ADDENDUM NO. 24

**Westfield Washington School Corporation
Bid Package 06, Bid Item #33
SR32 & Centennial Road New Roundabout Construction
17707 Centennial Road,
Westfield, IN. 46074**

ADDENDUM NO. 24

RE: Westfield Middle School – West

PLAN - LINE "PR-R"
STA. 500+00.00 TO STA. 503+00.00

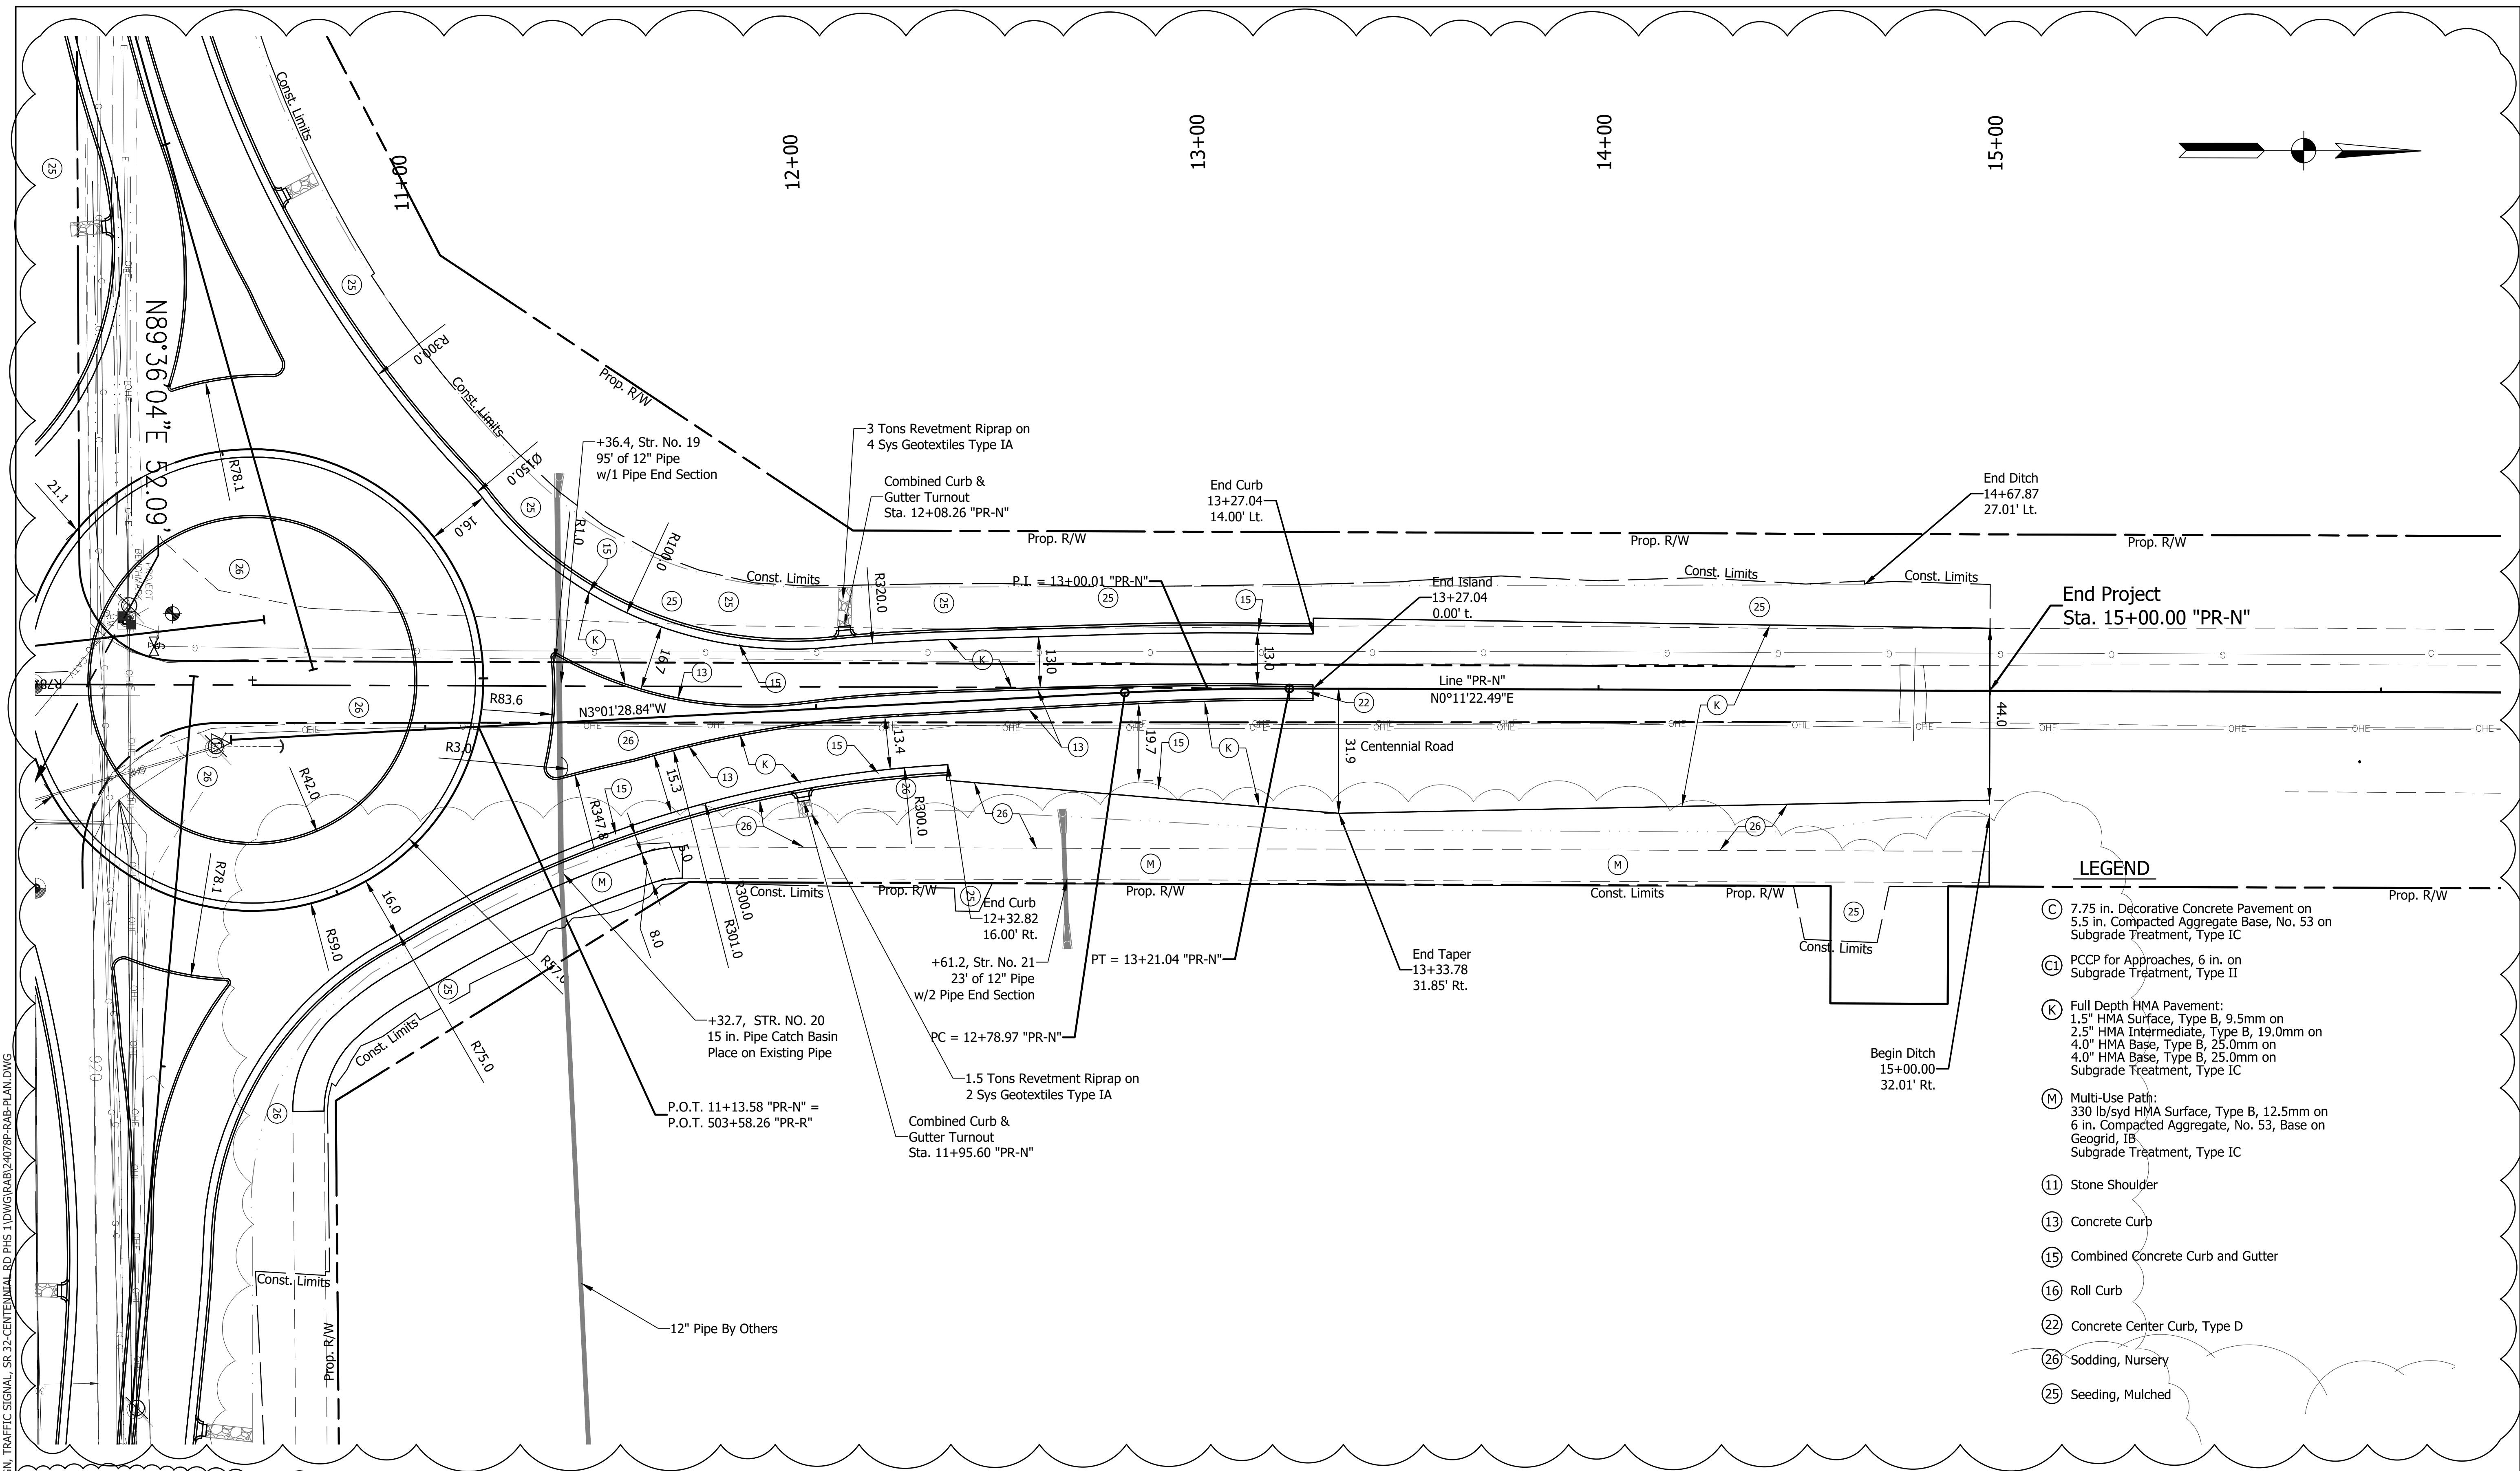
Q. Is there an earthwork summary table that can be provided? Do the cut and fill volumes on the cross sections include existing pavement removal?

REVISIONS	
ITEM	
09-28-2026	Added Construction Limits, Seeding Locations, Earthwork Summary Table, Changed Subgrades

A. Yes, this information is now provided in an earthwork summary table shown on Sheet 19 of the plans. Further, the cut and fill areas/volumes shown on the cross sections do include existing pavement removal since it is asphalt material.

CALCULATIONS FOR DIRT QUANTITIES
Summary

LINE	VOLUMES (CYS)	
	CUT	FILL
Line "PR-R"	533	2303
Line "PR-W"	852	203
Line "PR-N"	606	2196
Line "PR-E"	1705	307
Line "PR-S"	48	225

Subtotal 3744 5234

Shrinkage Factor 15%
Fill compensating for shrinkage 6019

Borrow Required 2275
Excess Cut 0

CROSS SECTIONS
LINE "PR-W"

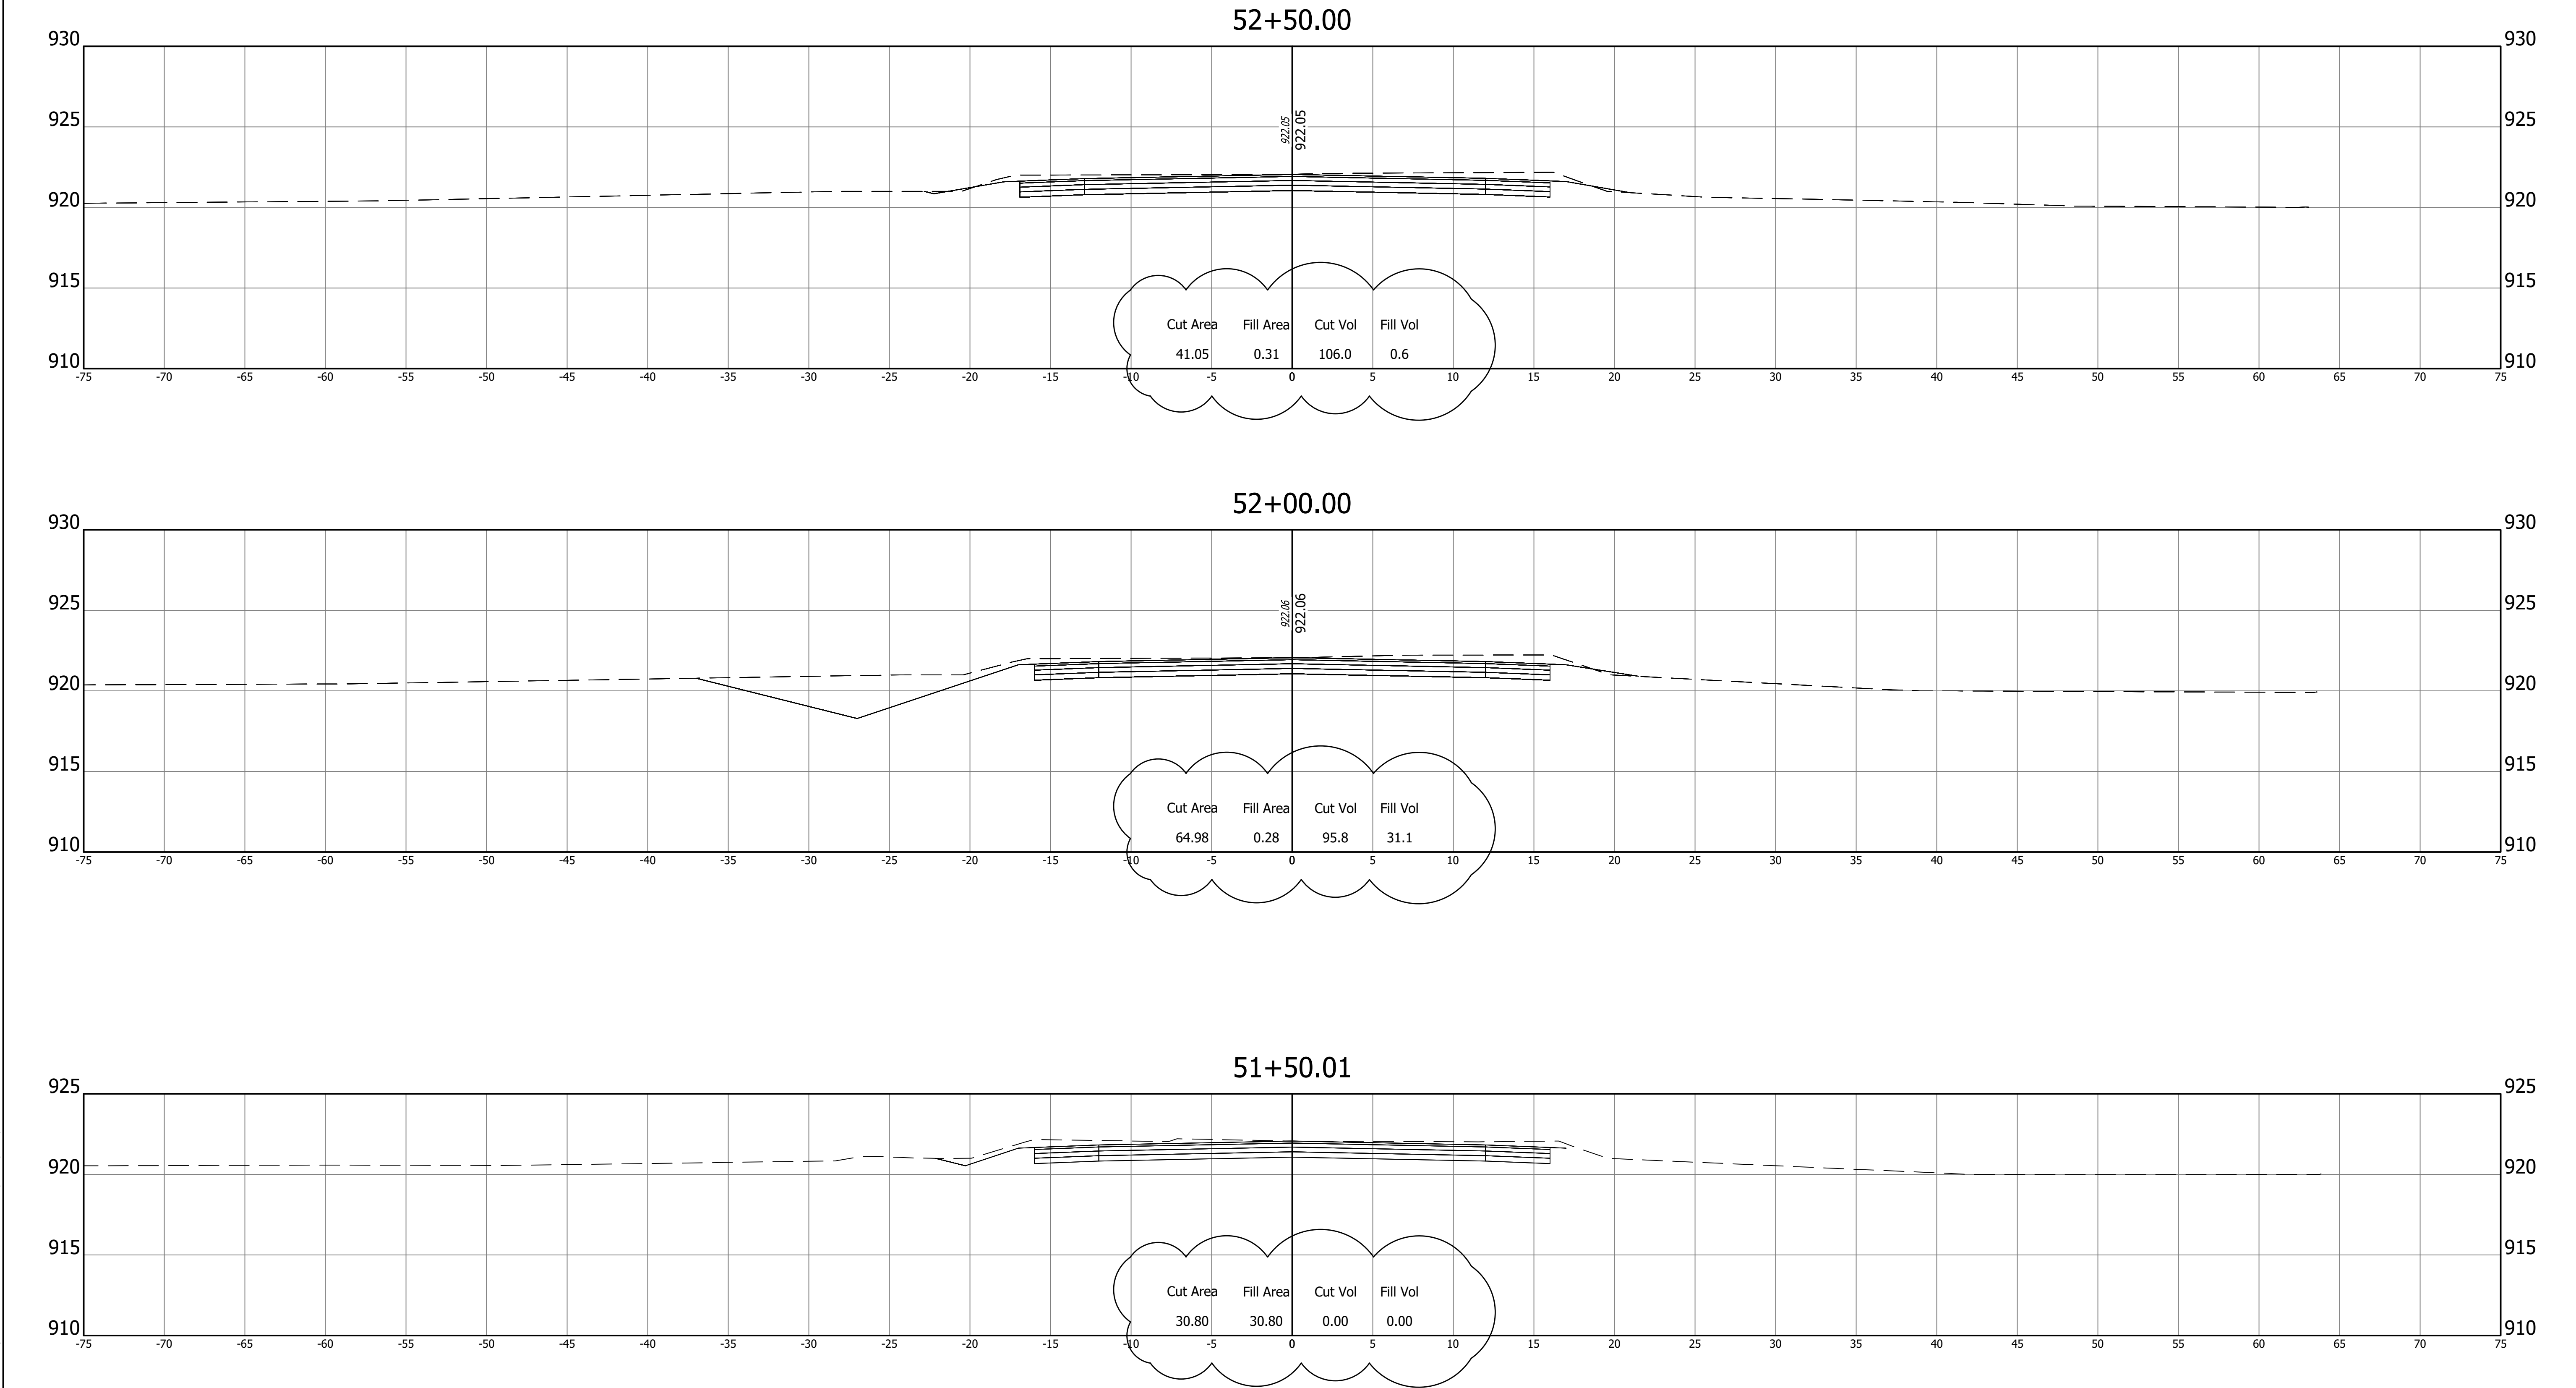
REVISIONS	
ITEM	
09-28-2026	Added Earthwork & Included Ex. Pvmt Rem.
